Request for Interpretation No. 51

AC Class Rule Version 1.5: July 20th 2016

Drawings ACC-1001-REVC CROSS STRUCTURE AREA.pdf, and ACC-11100-REVA MEDIA BAY GS.PDF

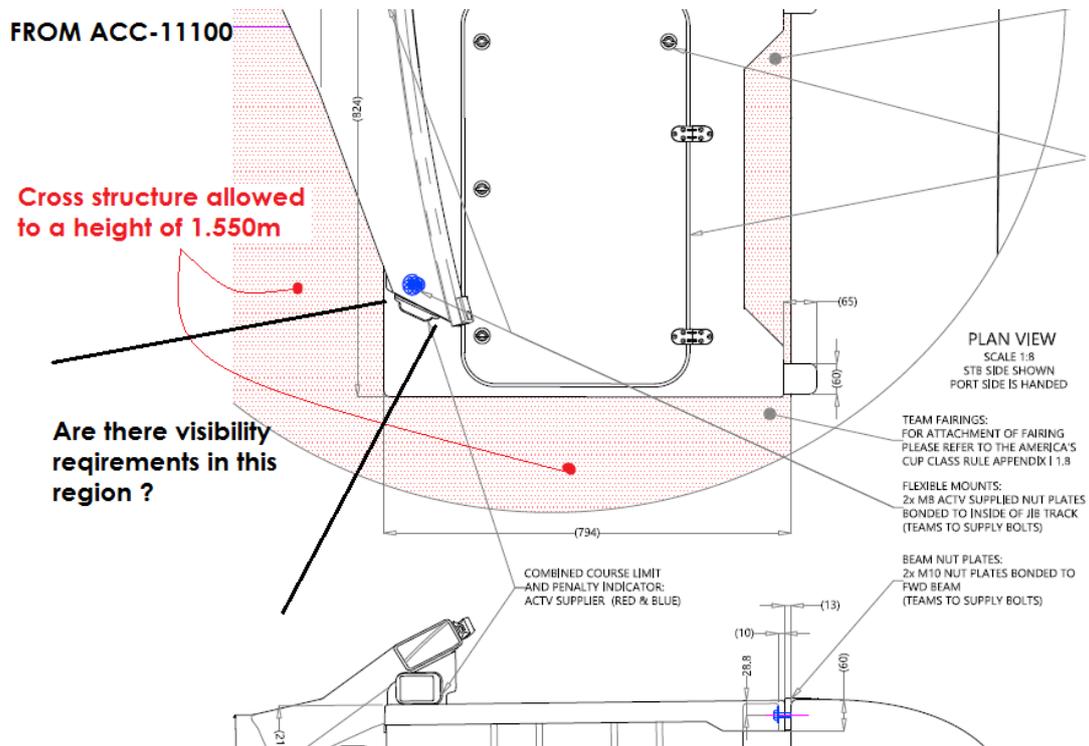
The **jib** track presents a significant source of aerodynamic drag. In the interest of the performance of the **AC Class Yacht** in all conditions, aerodynamic fairings in the region of the **jib** track are important. The **AC Class Rule** is silent with regard to how fairings can be integrated with components in and around this region, particularly as it relates to the required media bays.

1. With regard to the required reasonable access to the media bays per Appendix I 1.3, may permanent fairing structure be built in close proximity to the media bays along their aft, lower, and outboard surfaces, provided the lower surface has the VENT WATER OUTLET and RIDE HEIGHT SENSOR features shown in drawing ACC-11100? With this fairing structure installed, the media box could only be removed from above.
2. May an aerodynamic fairing which is not attached to the media bay cover the top of the media bay hatch while racing, provided the fairing is readily removable for access to the media bay?
3. The media bay appears to have an air vent intake on its outboard aft corner. If the answer to question 2 is "yes", are there specific clearance distances or other requirements in the area of this intake to allow air flow?

4. **Cross structure** is permitted aft and outboard of the COURSE LIMIT, PENALTY LIGHT, shown in drawing ACC-11100. **Cross structure** is permitted to a height of 1.550 m above **MWP**, which is above level of this light. Are there visibility requirements through the **cross structure** in this region? See diagram below.

1. Yes.
2. No.
3. Not applicable.
4. Yes. The lights must be easily visible to the crew at all times.
